Project: Bayfront Parkway Corridor Improvement Project | Roundabout Peer Review Workshop
 Monday, February 22, 2021

Subject: Roundabout Peer Review Workshop | Meeting Minutes

Bayfront Parkway Roundabout Peer Review

3 SCENARIO #2 + ADD NB RIGHT TURN LANE

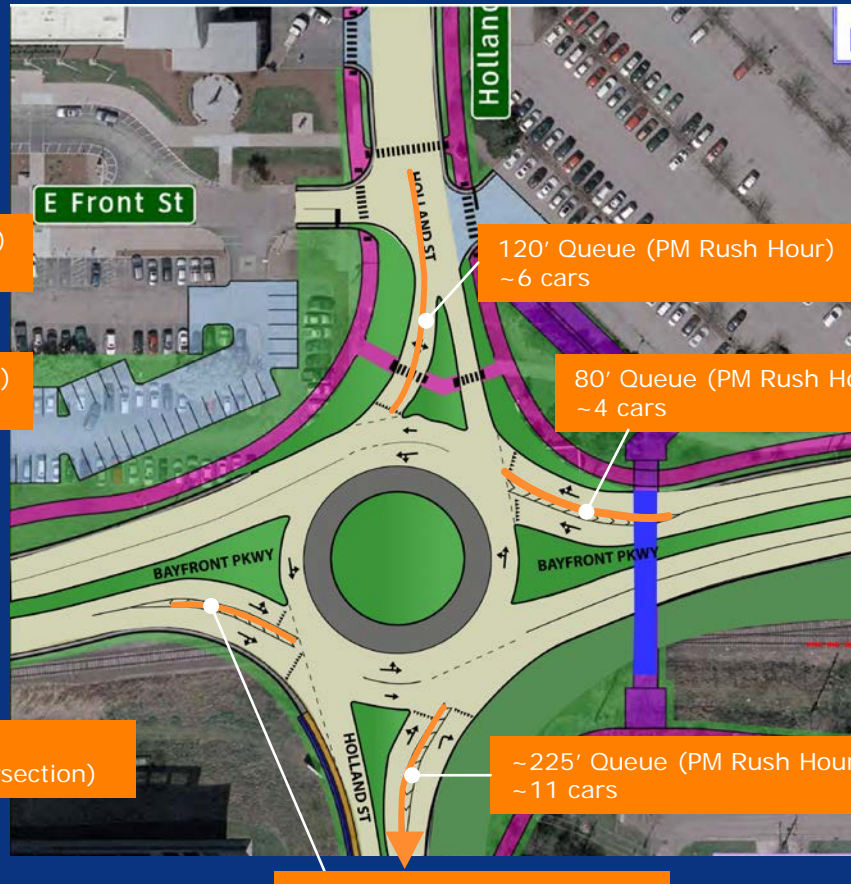
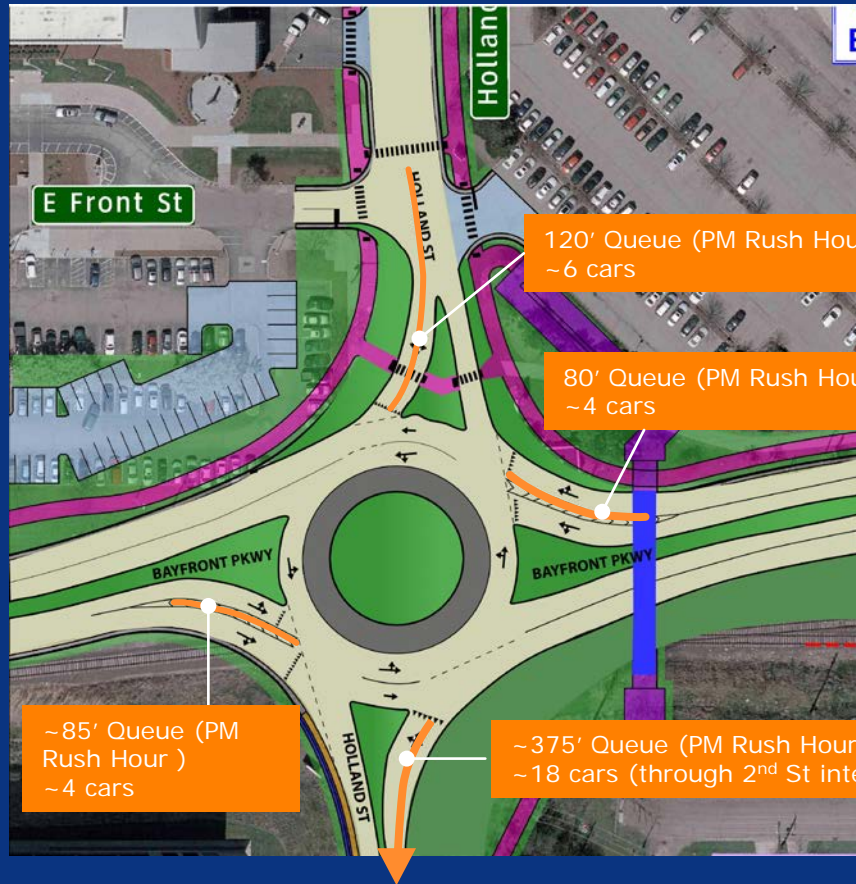
Scenario 3 : Scenario #2 + Add NB Right Turn Lane	
Delay (seconds)	16
Volume-to-Capacity*	0.85

4 CURRENT PENNDOT DESIGN

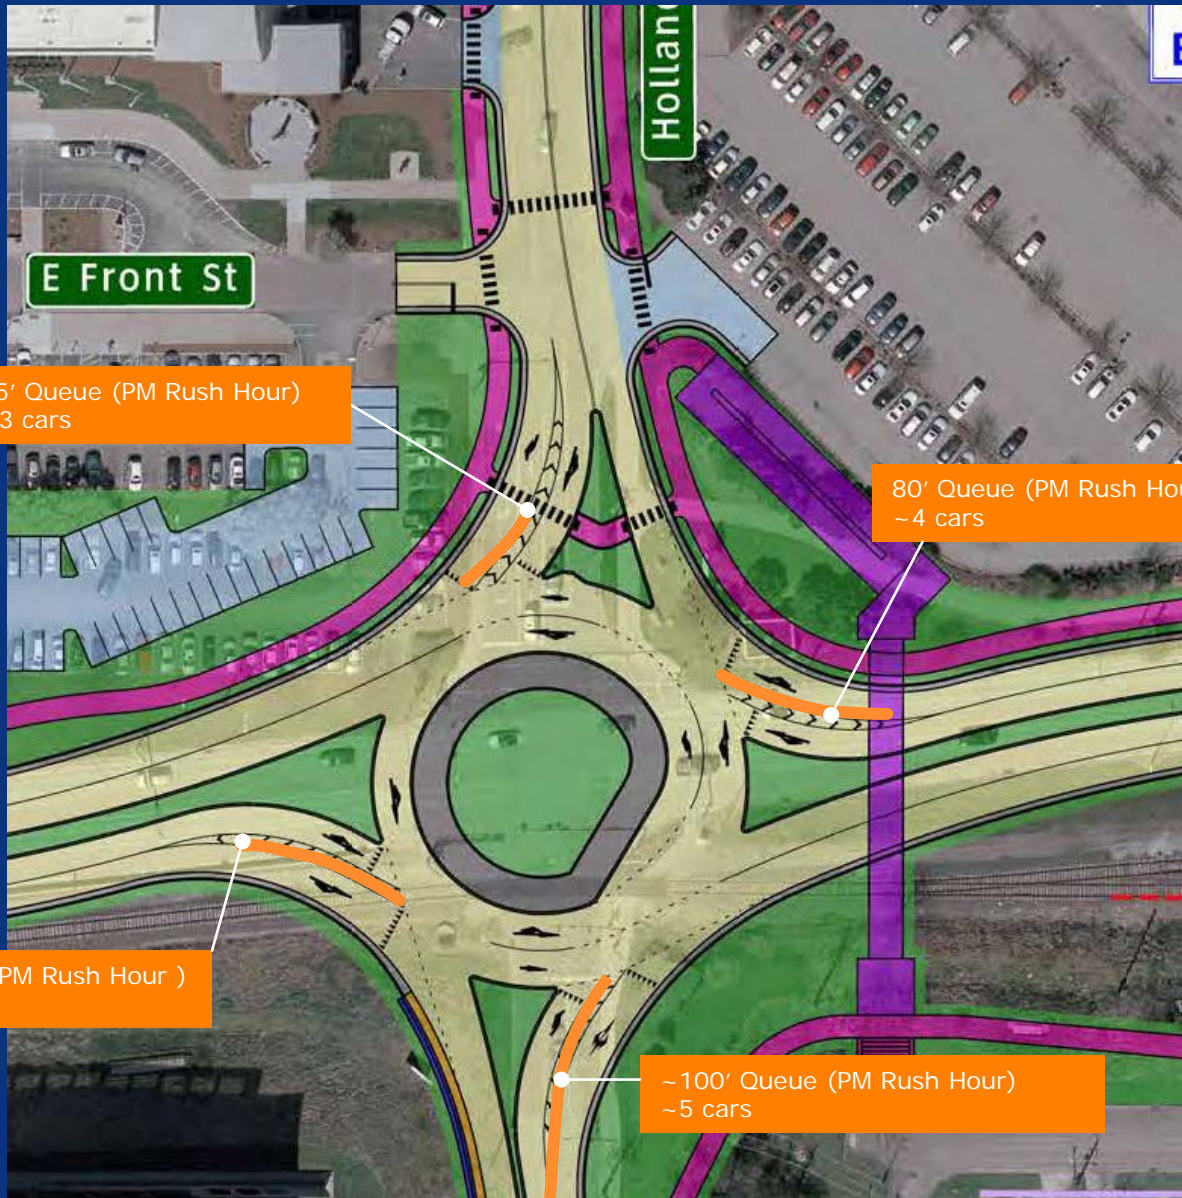
Scenario 4: Current PennDOT Design

Delay (seconds)	12
Volume-to-Capacity*	0.61

* Volume to capacity should be less than 0.95

COMPARISON – SCENARIOS 2, 3 AND 4

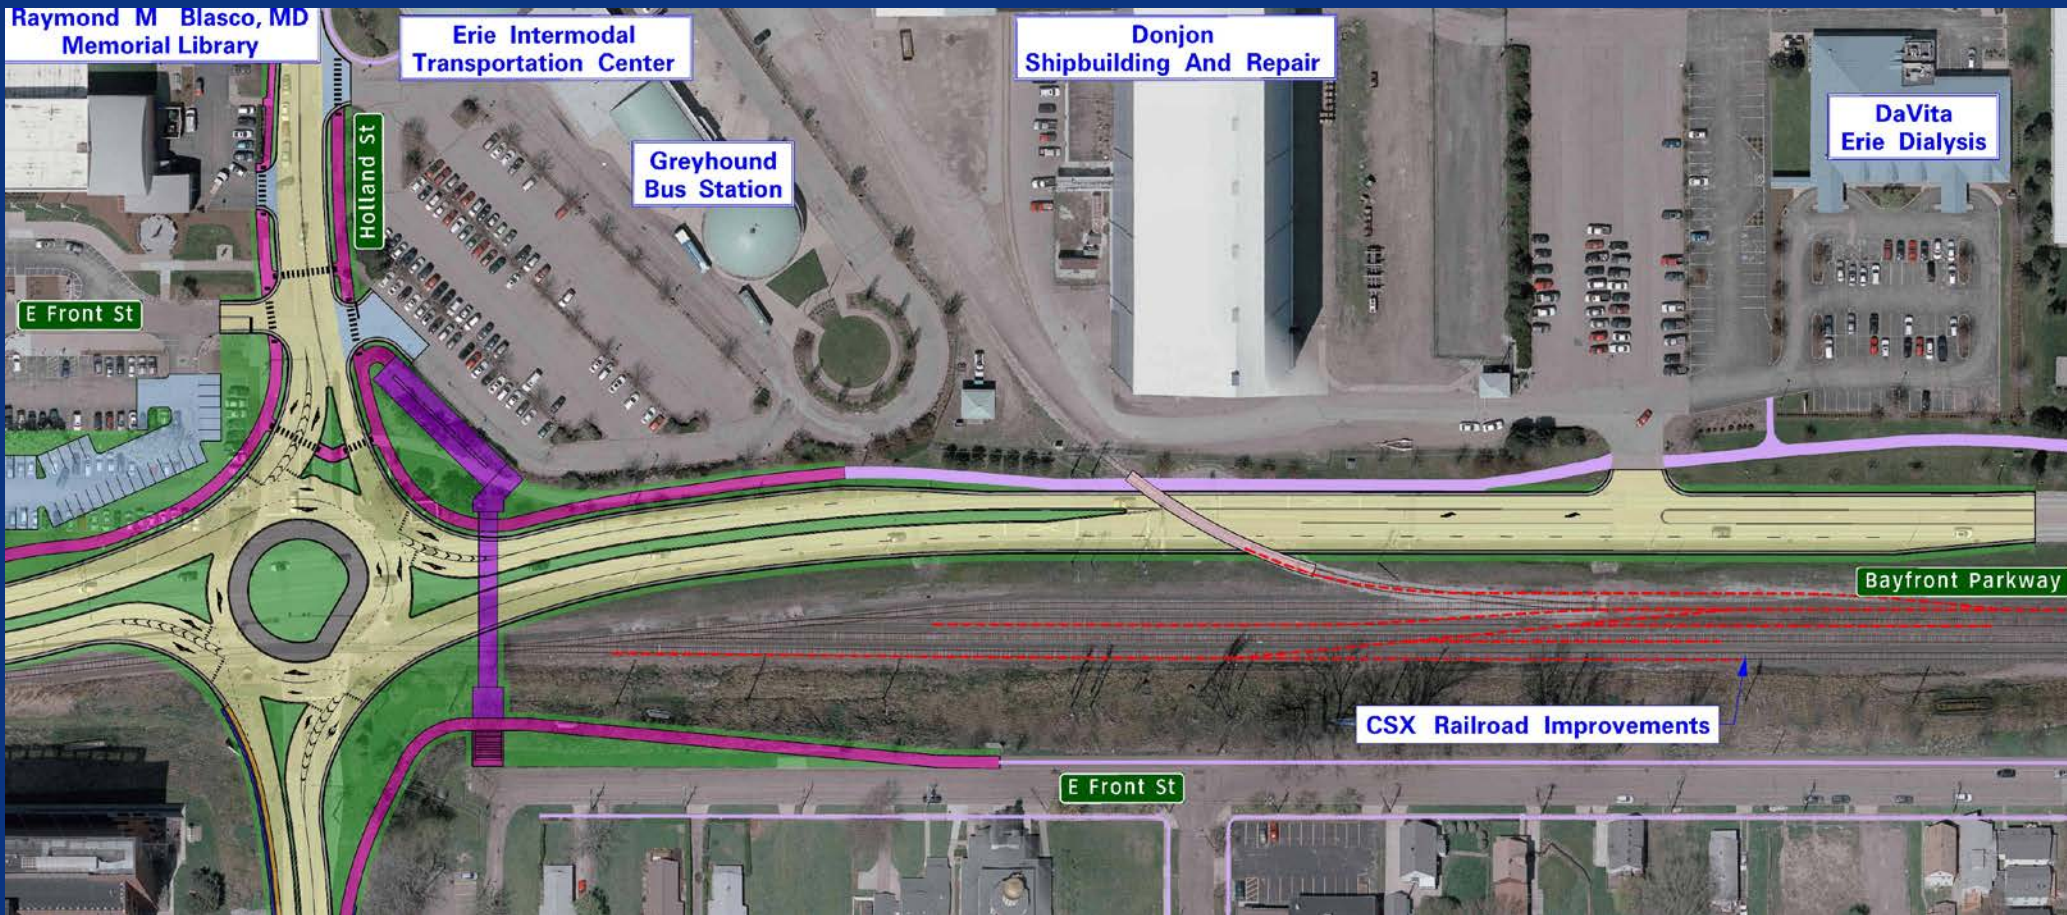
Scenario #2 Single Lane on Holland St	Scenario #3 Scenario #2 + RT Turn Lane on Northbound Holland Street	Scenario #4 Current PennDOT Design
Intersection Control Delay (seconds)	23	16	12
Max Volume to Capacity	1.01	0.85	0.61

BAYFRONT PARKWAY AT HOLLAND ST

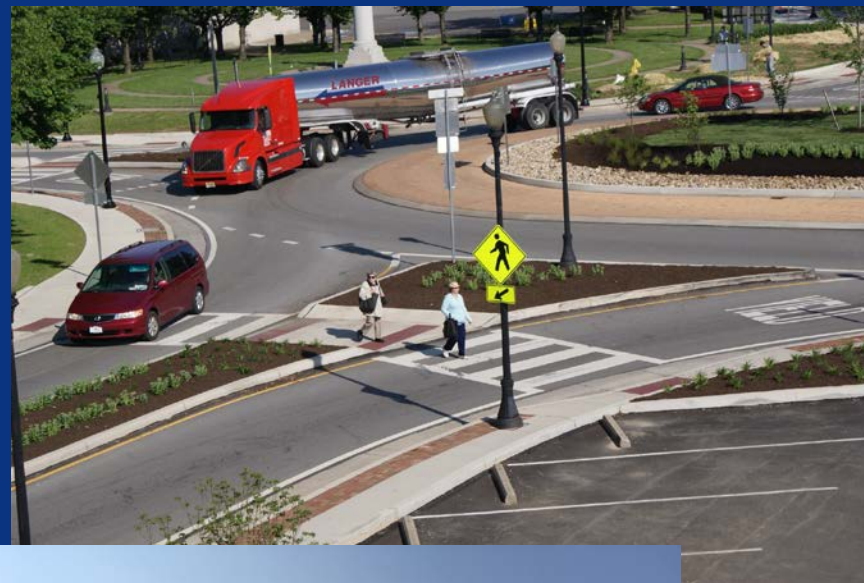
▪ Peer Review Recommendation → Holland Street Roundabout

- Simplifies the Roundabout
- Reduces Ped Crossing distance on Holland Street (38' → 18')
- Phasing the Rt Turn Lane → simpler configuration for as long as possible

- We recommend Scenario 2 over Scenario 4 (current PennDOT design)
 - Eliminate One (1) Lane on Holland Street (NB & SB)
 - Acquire right-of-way to allow for a future Right Turn Lane on NB Holland Street
 - Bayfront Parkway remains as previously proposed
